#### **ADDENDUM NO. 004**

Brighton Wastewater Treatment System Upgrades

June 2, 2025

A805

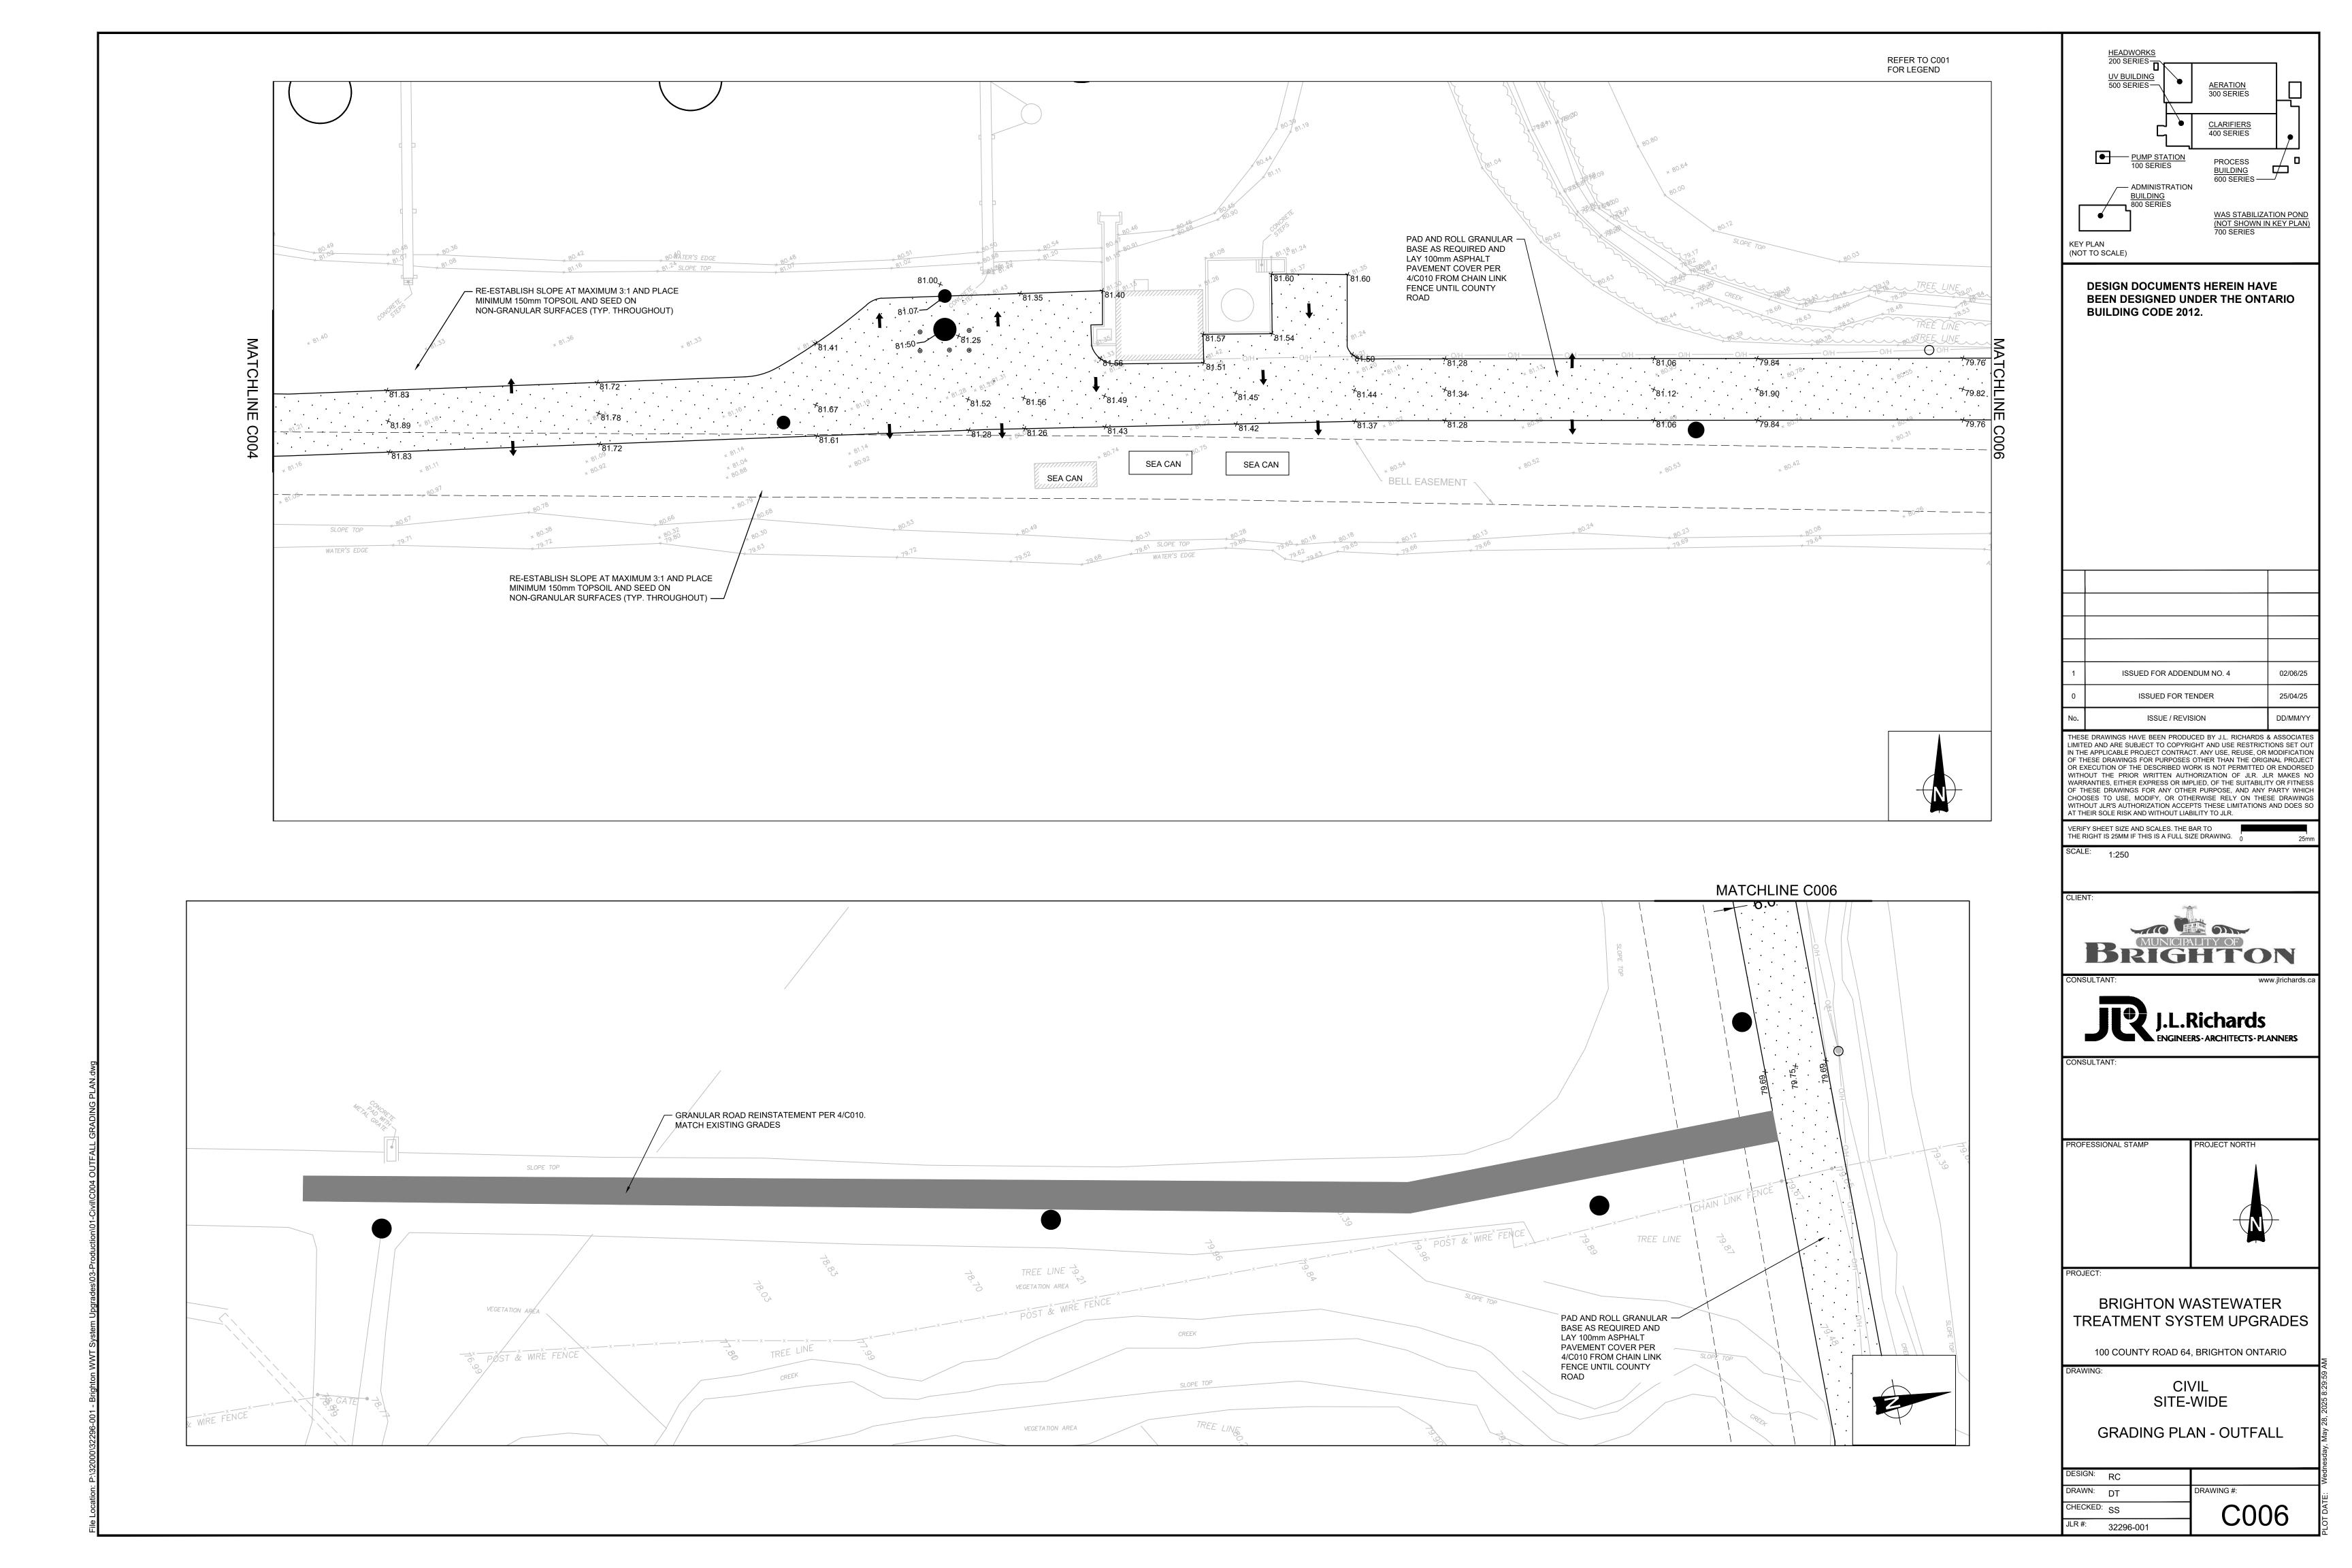
- 19.1 Detail #1 and #2
  - .1 **Revise** below grade waterproofing extension as bubbled.
  - .2 **Add** detail 1/A004, 2/A004, 3/A004, 4/A004 and 5/A004 callout.

MECHANICAL SCHEDULES SHEET 1

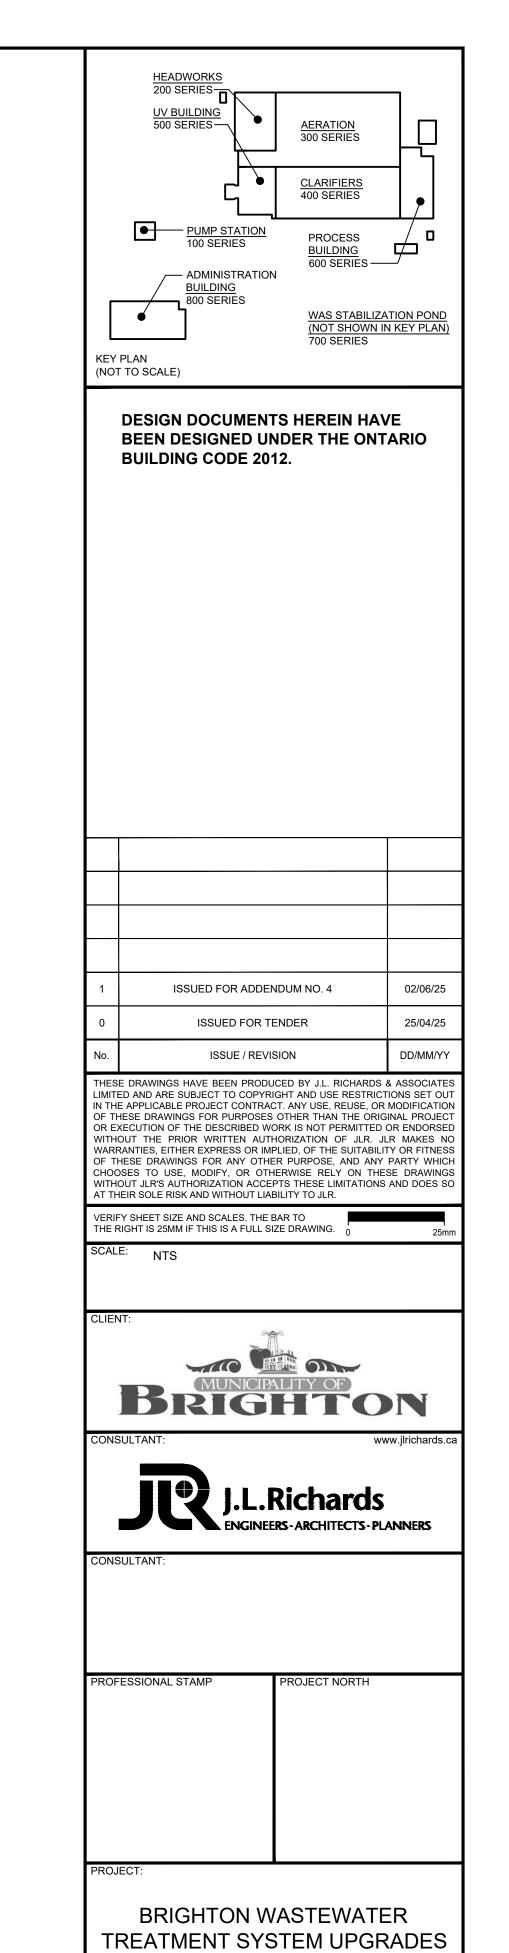
- 23.1 **Revise** Odour Control Unit Schedule as bubbled.
- 23.2 Add EBB 9816 to Unit Heater and Cabinet Heater Schedule.
